**ENGINEER'S DAILY REPORT**

REPORT NO. <b>644</b> {7-day} { + 210 Project Work Day}	DATE <b>September 17, 2008</b>	M T <b>W</b> T F S S (DAY)
NORMAL WORK HOUR: START: 6:00AM STOP: 3:30PM	WEATHER: CLEAR / SUNNY	
LOCATION :	Construction Field Office : Working Drawing Campus Office :	333 Burma Road, Oakland 94607 375 Burma Road, Oakland 94607

**04-SF-80-13.2/13.9**  
**Contract No. 04-0120F4**  
**{SAS Superstructure}**

# ATTACHMENT #4 (1/1)

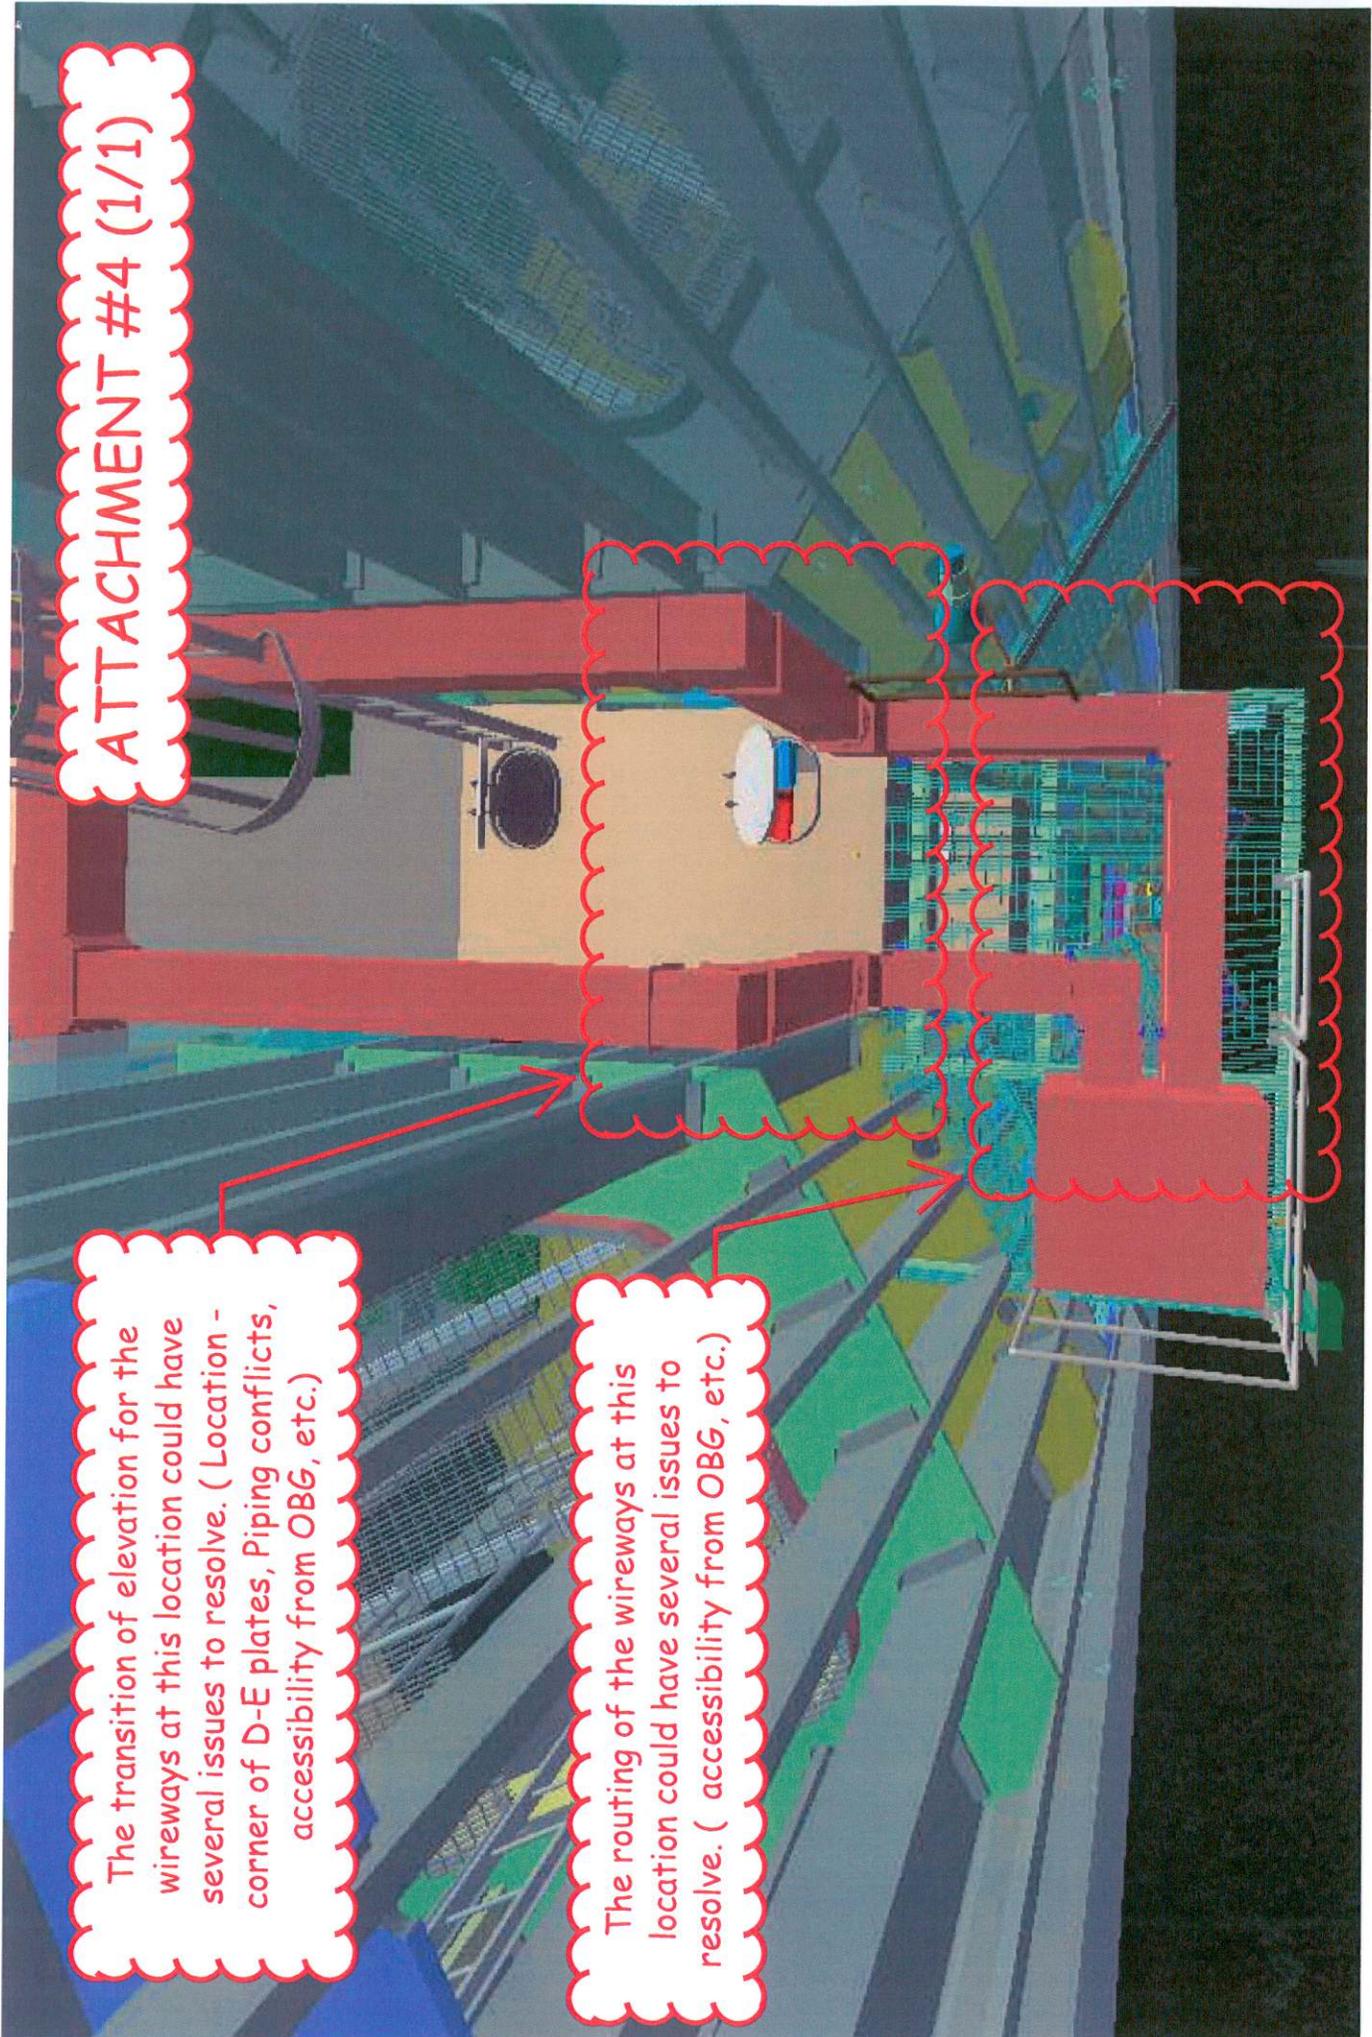
The transition of elevation for the wireways at this location could have several issues to resolve. ( Location - corner of D-E plates, Piping conflicts, accessibility from OBG, etc.)

The routing of the wireways at this location could have several issues to resolve. ( accessibility from OBG, etc.)
